Equipment Technical Bulletin

Summit OPL Flush Mandatory Firmware Upgrade

New programmer with new firmware: Check the firmware version displayed on the programmer at powerup; if it's V1.00 or V1.01, you need to replace it with a new programmer (code #068742). All programmers shipped from Beta after April 1st, 2004 have the new firmware version 1.02.

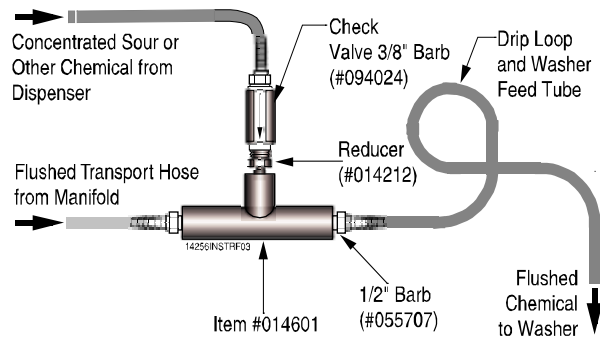
Summit units that use flush manifolds in the field need have their programmer (code #068742) replaced on their next service call. Summit OPL firmware resides in the programmer.

To change out programmers, use a cloning adapter 069458 to clone the old programmer's setup information to the new programmer. Leave the new ver 1.02 programmer attached to the pumpbox, and return the old programmer to Beta so it can be refurbished.
